SPECIAL SERVICE TOOLS  
SS95-002  
OCTOBER 27, 1995  
ALL MODELS

Title **ENGINE SUPPORT BAR IMPROVEMENTS**

00002-01724 TRIPOD ENGINE SUPPORT BAR KIT	00002-01724-U TRIPOD UPGRADE KIT
 BOLT	 BOLT

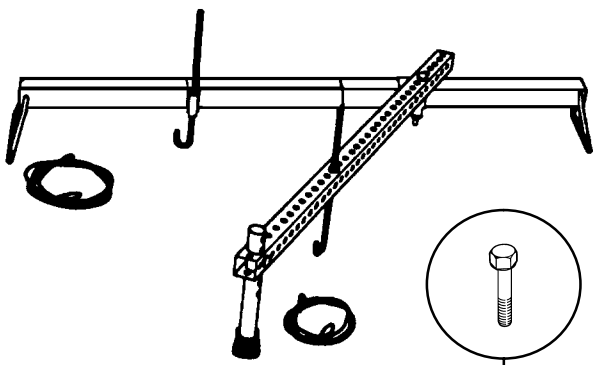
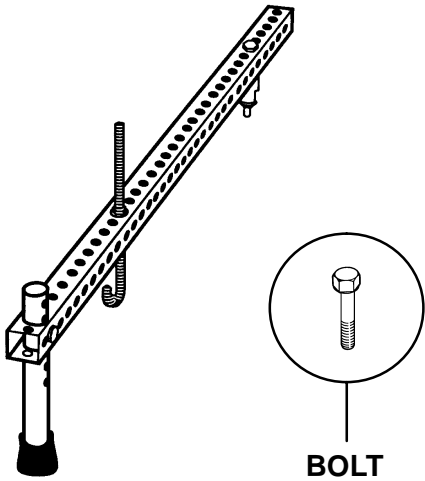
A new engine support bar, P/N 00002-01724, has been released by OTC. This new tripod design engine support bar, which is designed to support engine weight while transmission service is being performed, supersedes the current bipod engine support bar, P/N 00002-01722.

For dealers who currently own the 00002-01722 engine support bar, OTC has developed an upgrade kit, P/N 00002-01724-U which includes all necessary components and hardware to convert it to the new tripod design. **To avoid the potential for personal injury or property damage, do not use the existing engine support bar without the new upgrade kit.**
